Core Operating Limits Report

Dresden Station

Unit 2

ISSUANCE OF CHANGES SUMMARY

FIGURE 2.2-1

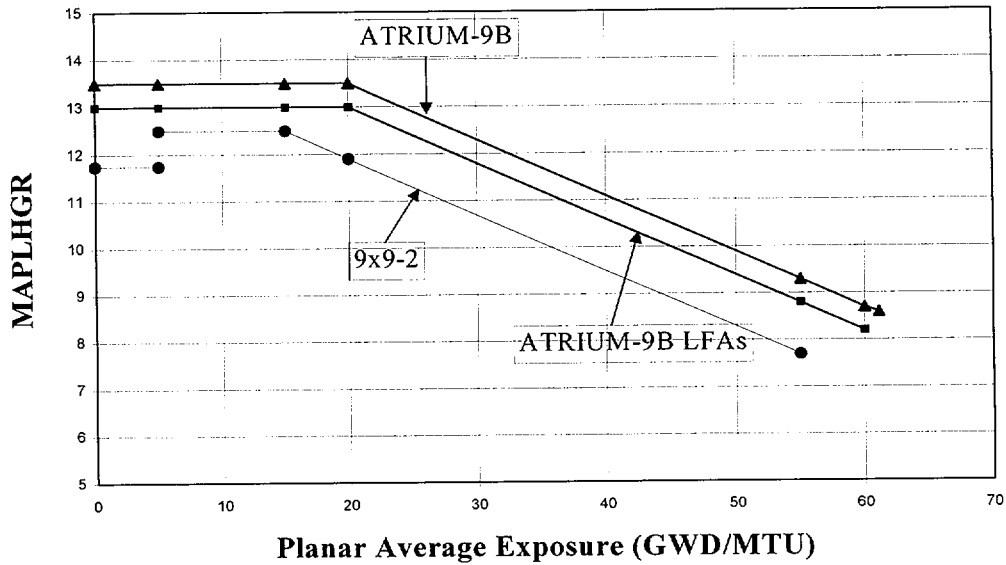
Affected Section	Affected Pages	Summary of Changes	Date
All	All	Original Issue Cycle 17	10/99
Figure 2.2-1	2-2	Figure 2.2-1 and the table below the figure were revised to reflect how the limits are implemented into the core monitoring code ¹ .	10/12/99
5.2	5-1	Section 5.2 item d was revised to clarify that during coastdown, operation is limited to the lesser of 100% CTP or the CTP calculated from items i or ii	10/12/99
Table 5.2-1	5-2	Table 5.2-1 was revised to a.) relocate the coastdown limits to a separate section of the table and b.) specify the exposures to which the coastdown limits are to be applied ²	10/12/99

¹ Powerplex can not implement a step change in an operating limit. Therefore, the COLR was revised to reflect a conservative implementation method for use in the Powerplex input deck.

0	11.75
5	11.75
5.01	12.5
15	12.5
20	11.9
55	7.7

0	13.5	13.0
5	13.5	13.0
5	13.5	13.0
15	13.5	13.0
20	13.5	13.0
55	9.3	8.8
60	8.7	8.2
61.1	8.6	-
